## **Mars Society Engineering Report**

from the Mars Desert Research Station (MDRS)

Report By: Joseph Palaia

6/26/2017

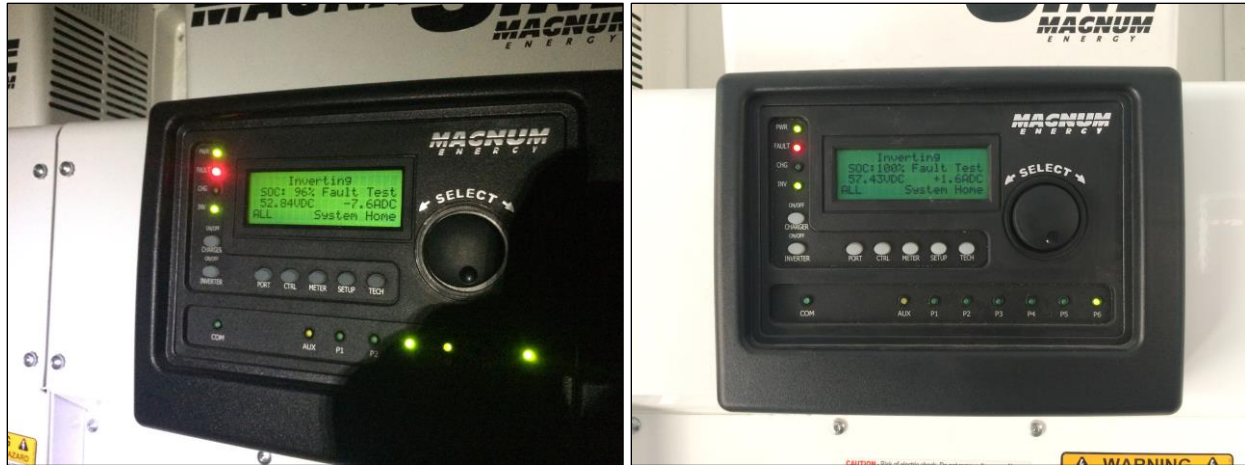
There was an additional breaker box labeled C.C #1 PV Array Input and PV MPPT Output, and C.C.#2 PV Array Input and PV MPPT Output.
